Ground Floor Plan

AS PROPOSED PLANS

Rev: E 19/10/21 -additional notes added and lowering of windows to second floor omitted at request of Conservation Officer

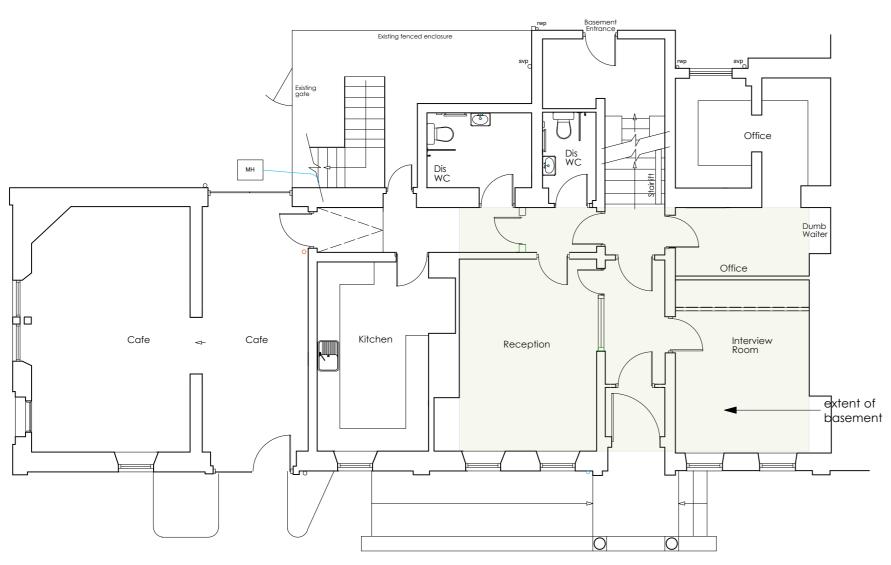
existing modern ramp removed and steps re-instated to frontage - paving repaired in new stone flags. Part M - Wheelchair accessibility is removed from the building, this impacts on compliance of Apartment 2. The remaining Apart 1 has a rear level access. The internal stairlift is removed from the stairwell to re-instate the original staircase.
